Change of approval and rating markings on the moulding body.

Product CI	Product Change Notification						8843-2 SP Change of inscription			
owner	creation date	release date	released by	change order no	rev	page	D40 040 406			
sariogar	09.01.2020	18.03.2020	sariogar	2018961	Α	1 of 2	D10-042-126

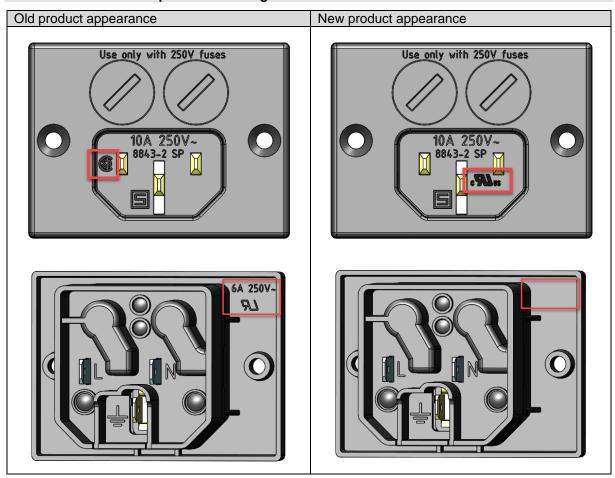
Approvals CSA and UR replaced to cURus. 6A 250V~ removed.

Standards update according to the new UL/CSA 60320-1
